**TOWN LAKE OF PARK
PLANNING & ZONING BOARD
STAFF REPORT
MEETING DATE: April 3, 2023**

APPLICATION: Oceana Coffee Roasters Site Plan Amendment

RE: Project No.: 5589
Project Name: Oceana Coffee Site Plan Amendment #1

1 WEST EXTERIOR ELEVATION
SCALE: 1/8" = 1'-0"

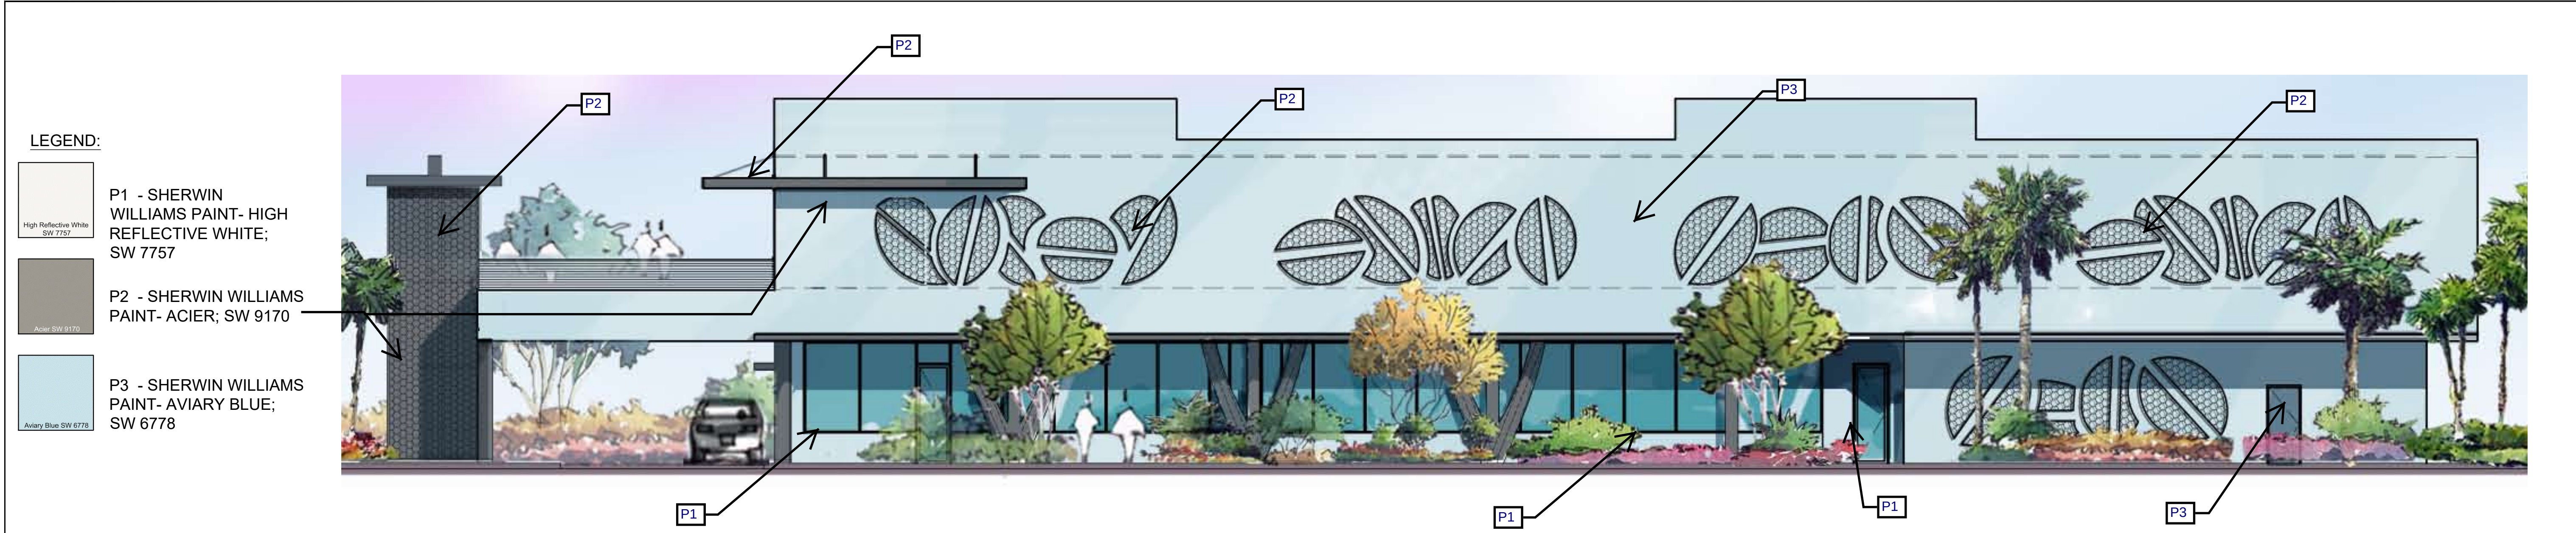
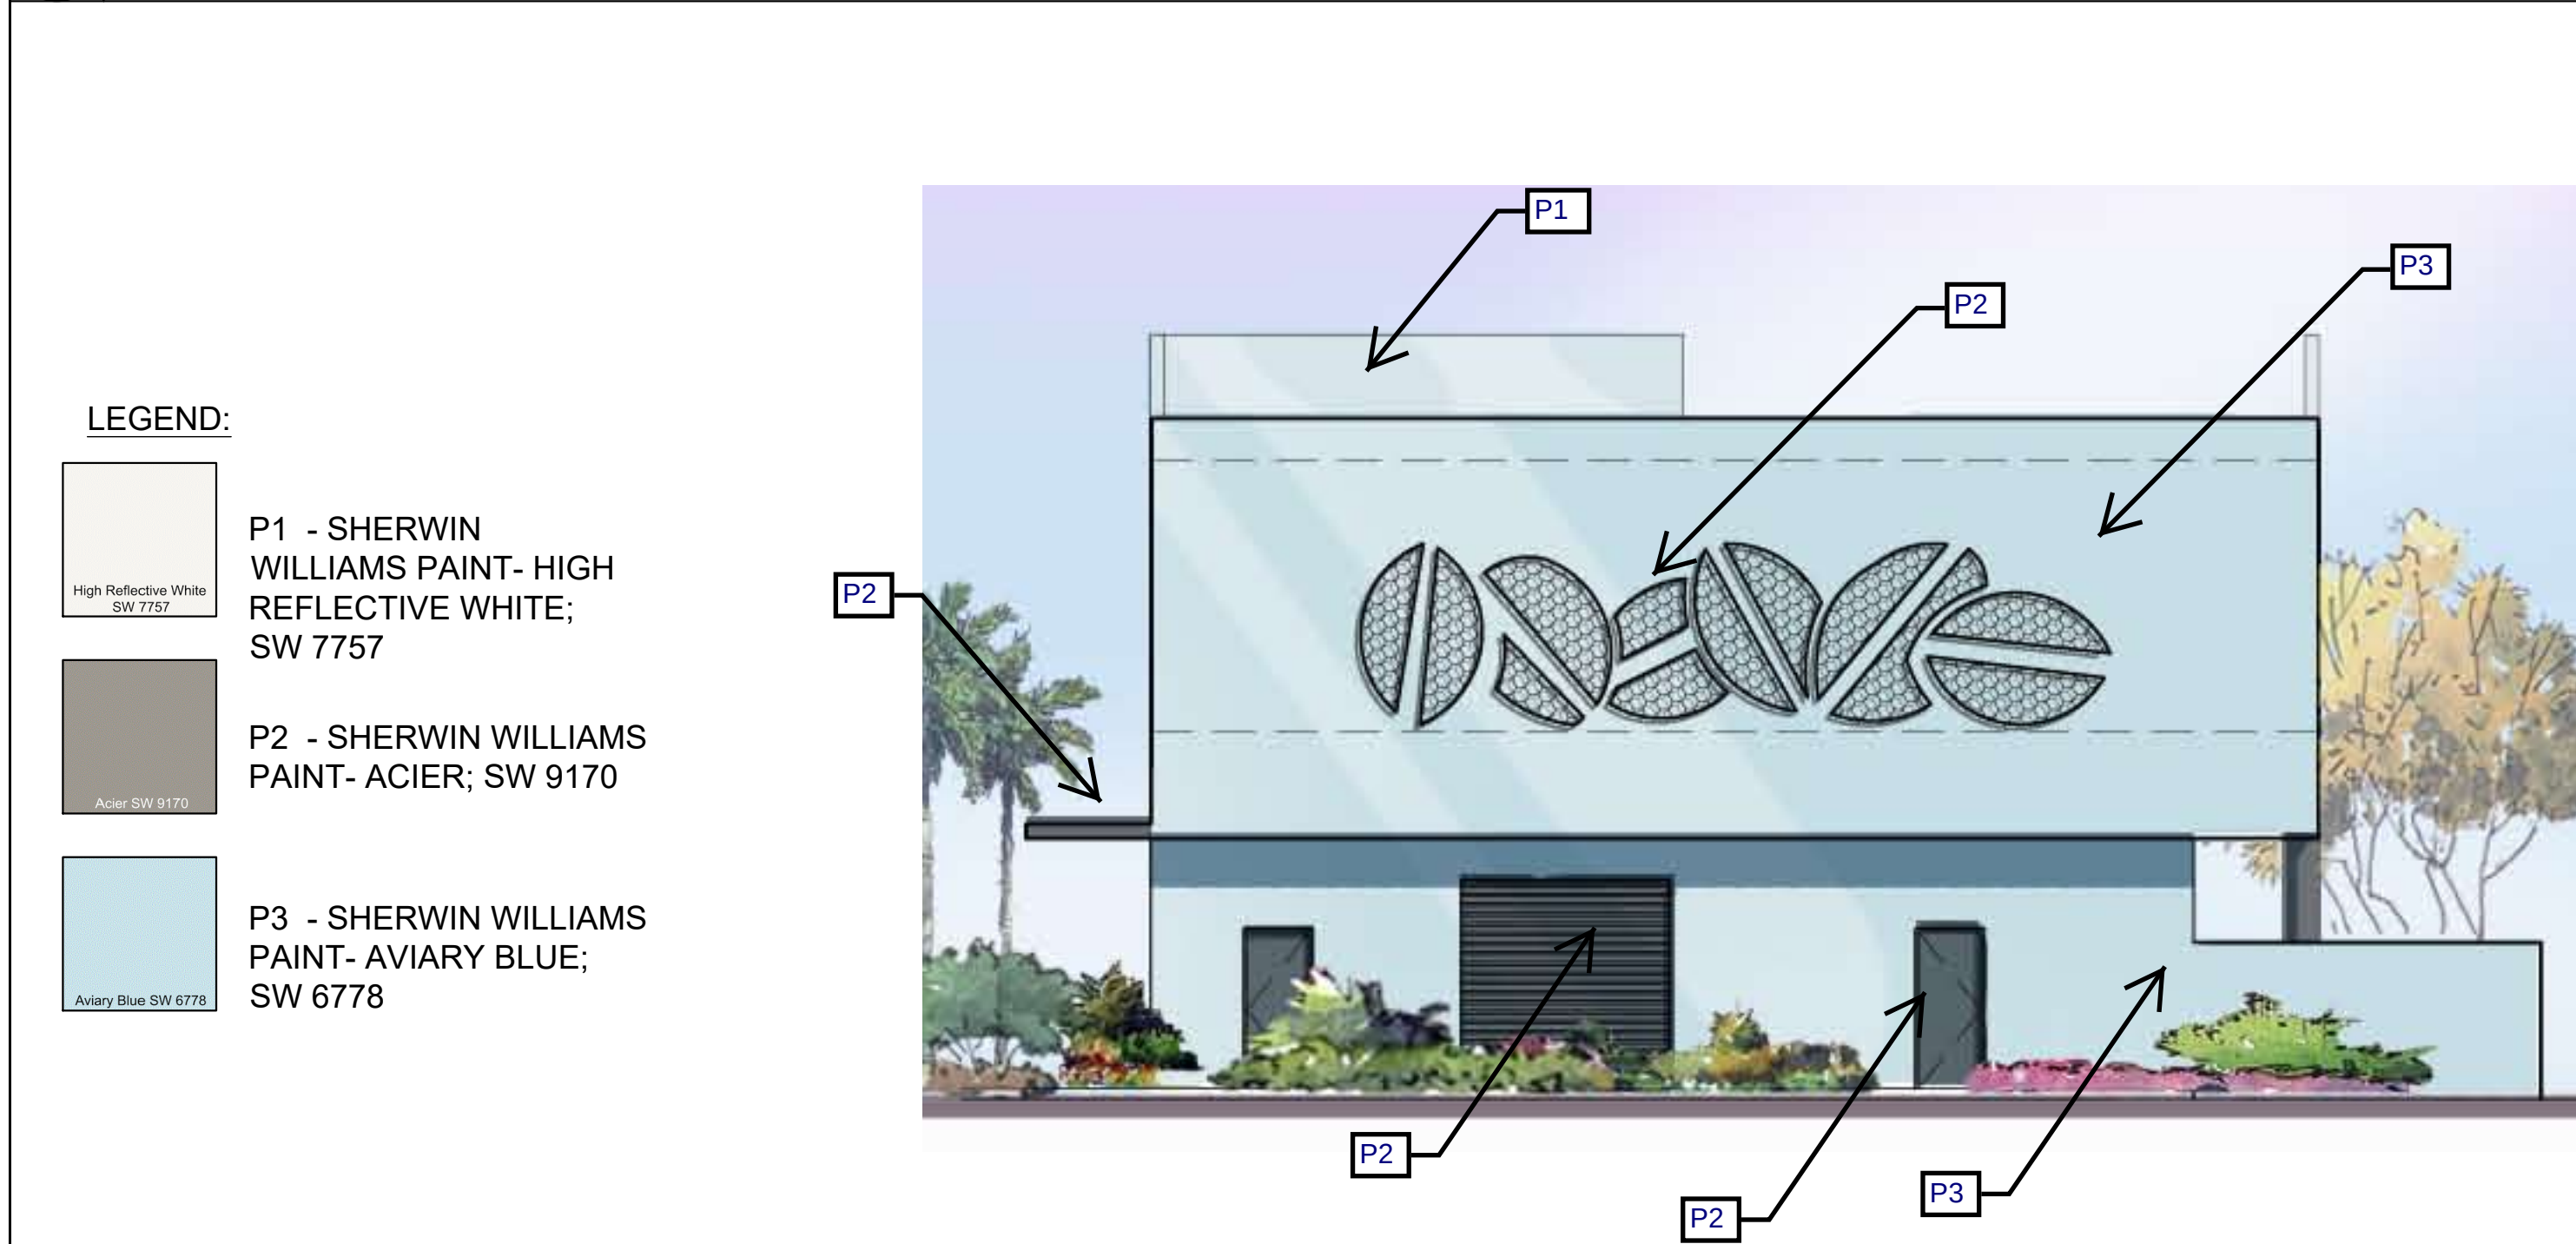
8. Renderings need to be consistent with all plans. For example, the northern stairway as shown in the rendering is not oriented in the same direction as the landscape plan depicts. In addition, the dimensioned elevations (A-201 and A-202) illustrates the screen around the stairway different than the rendering illustrates it. Please make these and other features consistent across all plans sets so that Staff understands the true proposal. Another example are the two doors on the second level depicted in the rendering. The dimensioned elevations (A-201 and A-202) depict one double-door configuration, along with the overhead canopy positioned differently. The metal panel coffee beans are also different in quantity and positioning on the renderings versus the dimensioned elevations. Another example is the first-floor drive-thru area that is

rendered with metal panel coffee beans on the wall and a canopy over the drive-thru window whereas the dimensioned elevations do not illustrate these features. The renderings also do not adequately illustrate the northern outdoor landscape/hardscape area as they are detailed on the site plan sheets.

On the west elevation on the north side, the canopy feature is not consistent between the black and white (A-201) and color elevation (A-202) sheets (just one example); please revise and ensure A-202 matched A-201.

RESPONSE: Rendering has been revised to reflect all the stipulated modifications as delineated in the site plan comments.

RESPONSE#2: Please refer to revised renderings & A-202

**1
E-3** **ELECTRICAL SITE PLAN**
SCALE: 1" = 20'-0"

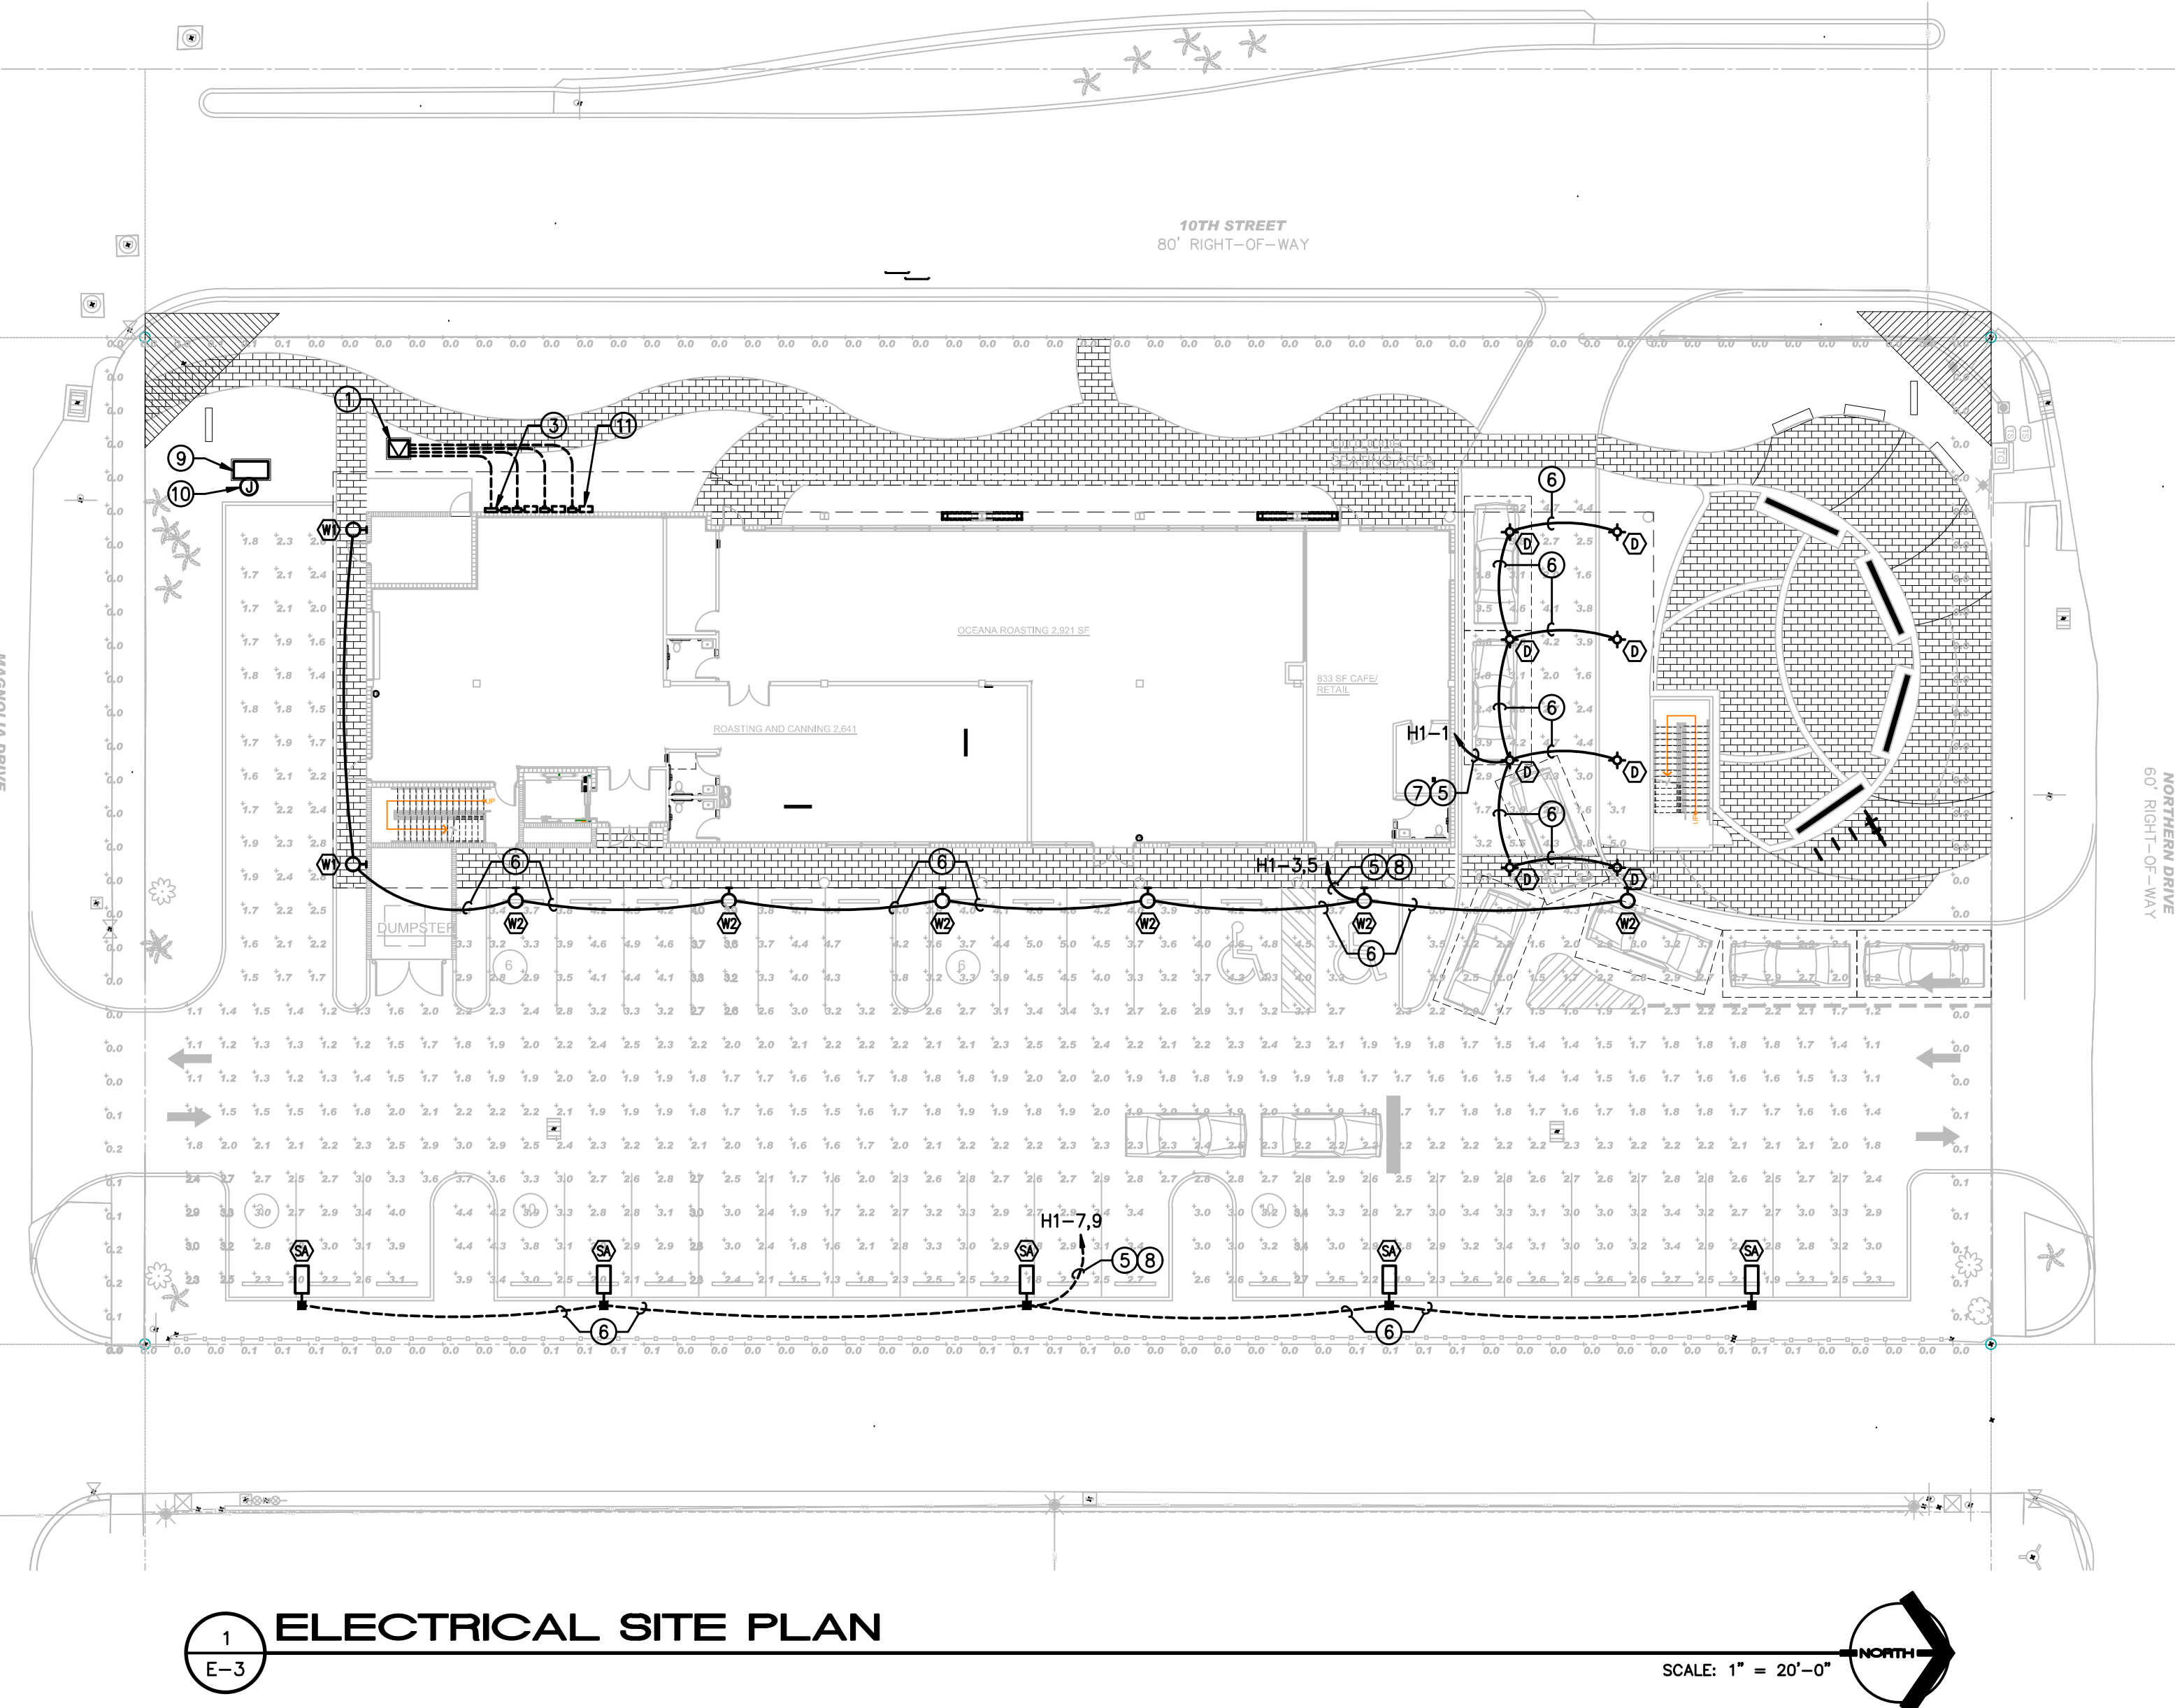
2. **Plan Sheet E-3 shall be updated prior to the issuance of the master building permit for construction to reflect a minimum 1 foot-candle of illumination in all publically accessible areas and entrances, for security purposes.**
3. The Owner, Applicant and their successors and assigns shall remain subject to all of the conditions of Resolution No 82-12-21 to the extent it is not modified herein, **including commencement of construction within 18 months of December 15, 2021, the date of this resolution. The Project shall be completed within 18 months of the date of the issuance of the building permit commencing the Project.**
